Panel Report

**Melton Planning Scheme Amendments C146 and C147
Plumpton and Kororoit Precinct Structure Plans**

27 February 2017

Figure 1 Plumpton future urban structure

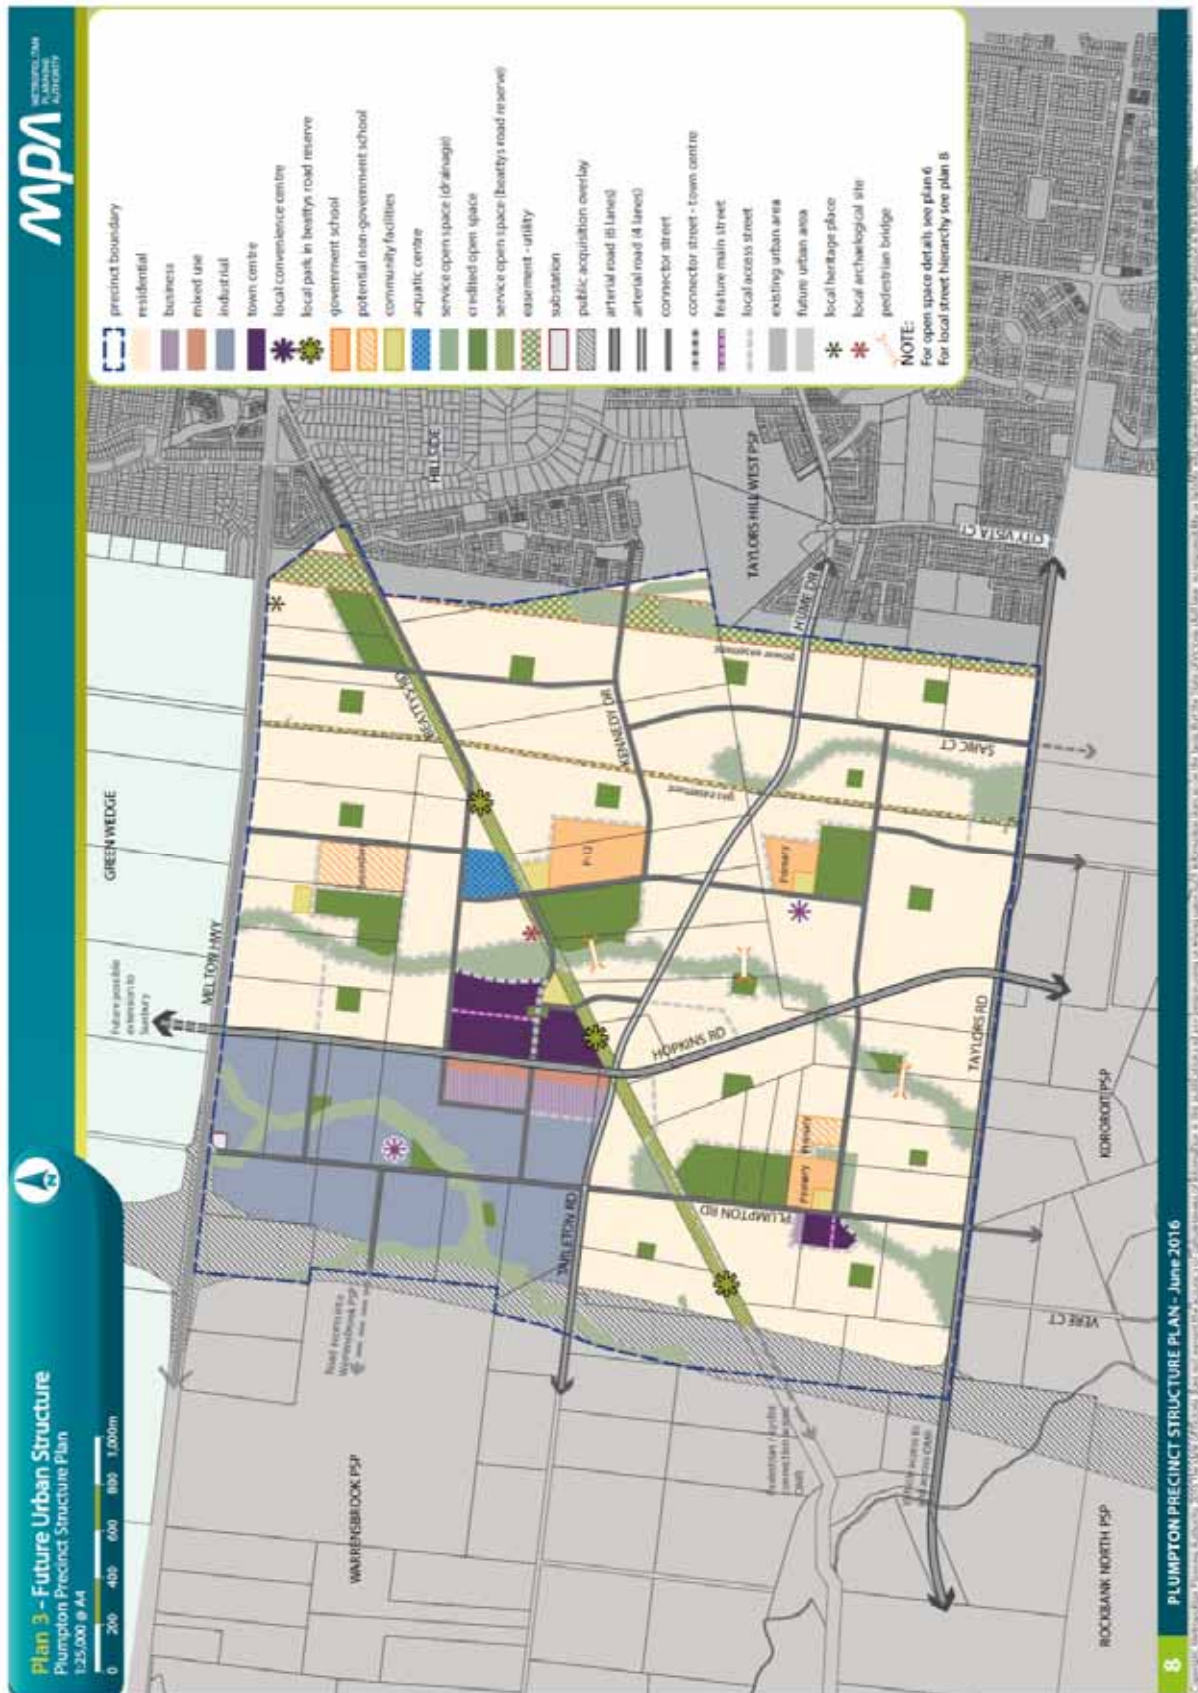
Dahua Dacland proposed an alternative configuration to that shown on the exhibited PSP Plan 3 – Future Urban Structure. The proposed configuration would rotate the P-12 School to an east-west direction with a full interface to Beattys Road linear park; orientate the Sports Reserve (SR-04) east-west and locate it directly south of the P-12 School; and shift the Community Centre (C1-02) to directly abut Beattys Road to the north and the P-12 school to the east. A re-drawn version of the alternative configuration was tabled by the VPA as Appendix D to its closing submission as shown in Figure 7.

The Panel notes the re-drawn layout plan (included as Appendix 7 to the VPA's closing submission and reproduced as Figure 7 in this report). This re-drawn layout was adapted to match the style of the PSP and is materially unchanged from the layout submitted by Dahua Dacland with the exception that the alignment of the north south connector street has been revised to run along the east side of the aquatic centre to provide an improved north south connection. This change was suggested by the Panel and supported at the Hearing by Mr Gnanakone.

27. Amend Plan 3 – Future Urban Structure and other relevant plans in the Plumpton Precinct Structure Plan to reflect the revised community hub layout as depicted in Appendix 7 of the Victorian Planning Authority’s closing submission.

Figure 2 Kororoit future urban structure

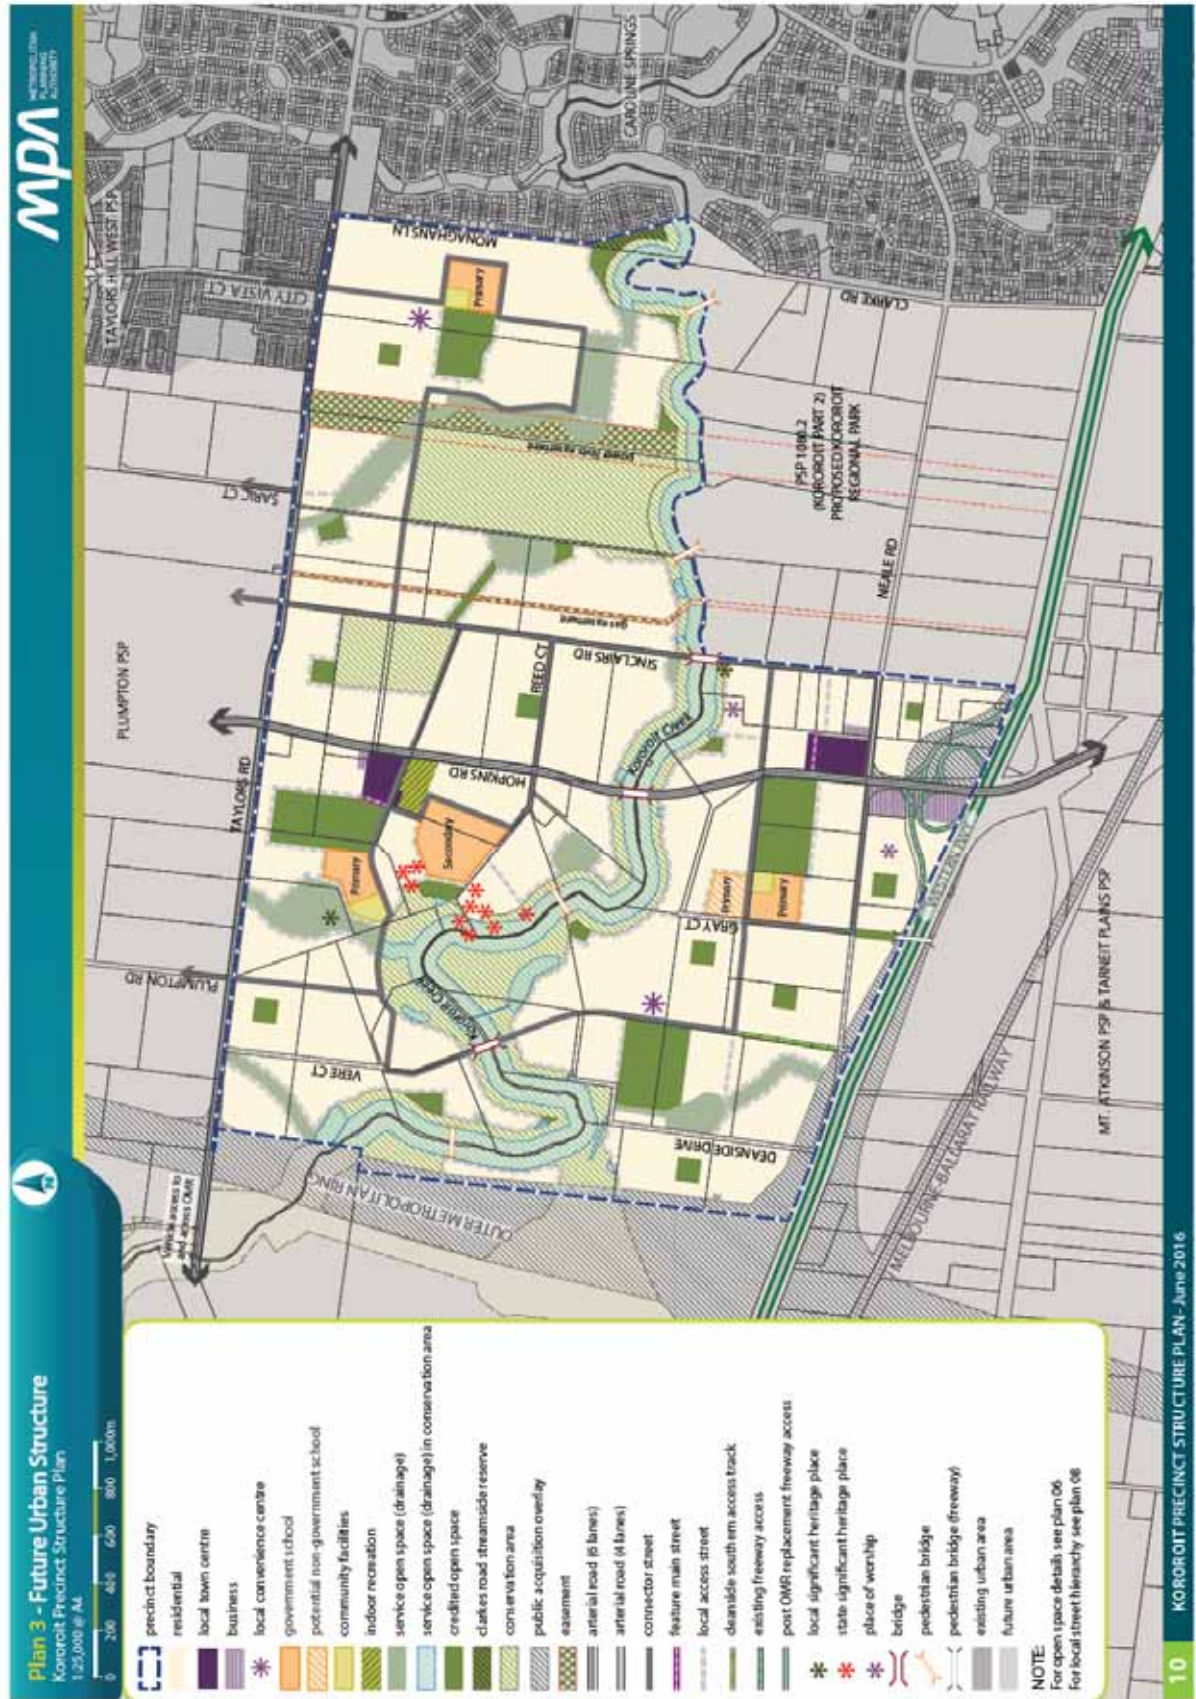
49. Amend Plan 5 of the Kororoit Precinct Structure Plan to include a notation that the north-west corner of Hopkins and Neale Road is a gateway site.
50. Amend the Future Urban Structure (Plan 3) in the Kororoit Precinct Structure Plan to reflect the revised proposal for the Deanside 10 hectare Sports Reserve, as provided for in Appendix 6 of the Victorian Planning Authority closing submission.

Figure 3 Utilities plan Plumpton PSP

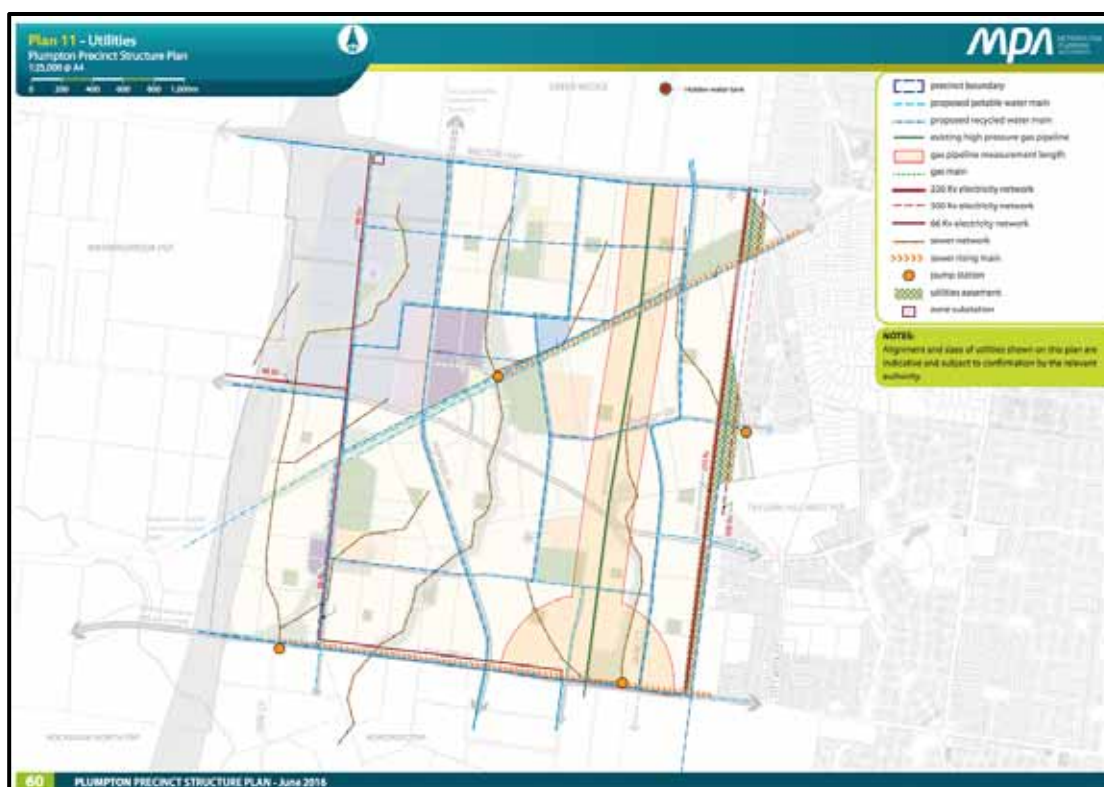
An application to use land for any of the following uses within the 'gas pipeline measurement length' shown on Plan 11 Utilities in the incorporated Plumpton Precinct Structure Plan must be referred to the gas transmission pipeline operator:

These pipelines affect both the Plumpton and Kororoit PSP areas, running in a north-south direction east of Hopkins Road and are identified on the corresponding Utilities Plans 11, within the PSPs as shown in Figures 3 and 4 (shaded orange).

Figure 9 Extract of Figure 7 in the Kororoit PSP showing the Natale property

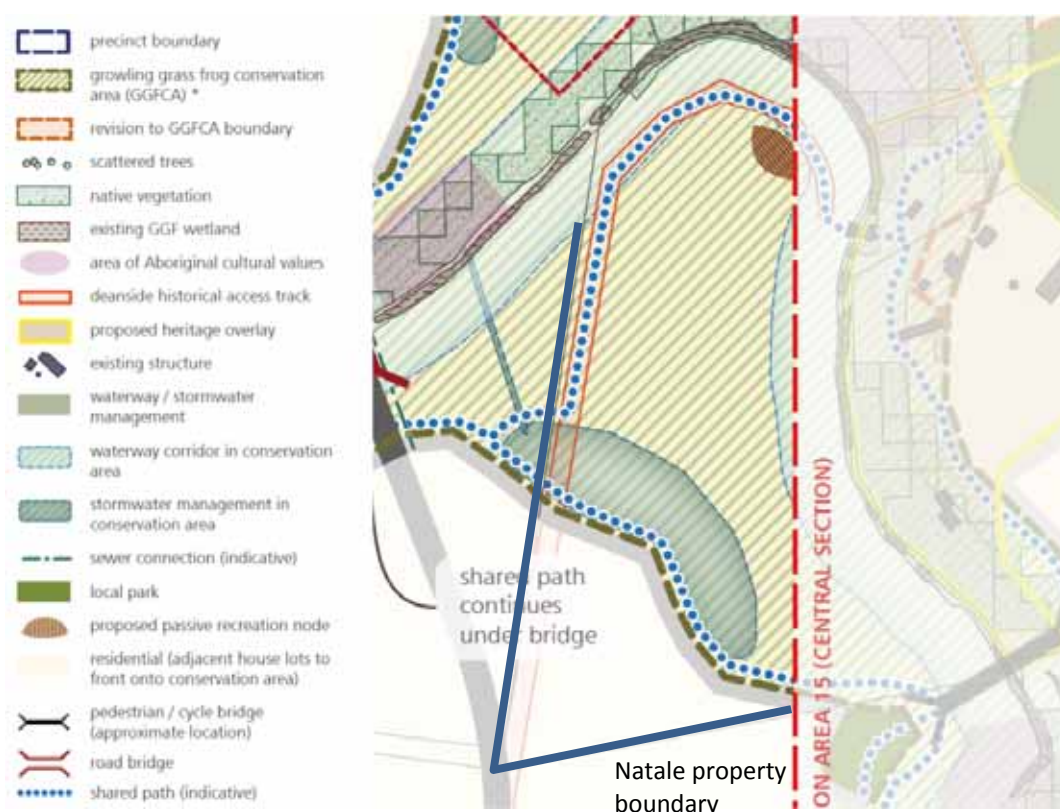
The majority of the Natale land is affected by the GGF CA as shown on Figure 9.

- Whether the Panel ought to recommend changes to the GGF CA
- The appropriateness of the boundaries of the GGF CA
- The location of Melbourne Water assets WI-08 and WI-09
- The location of the shared paths on Mrs Natale's land.
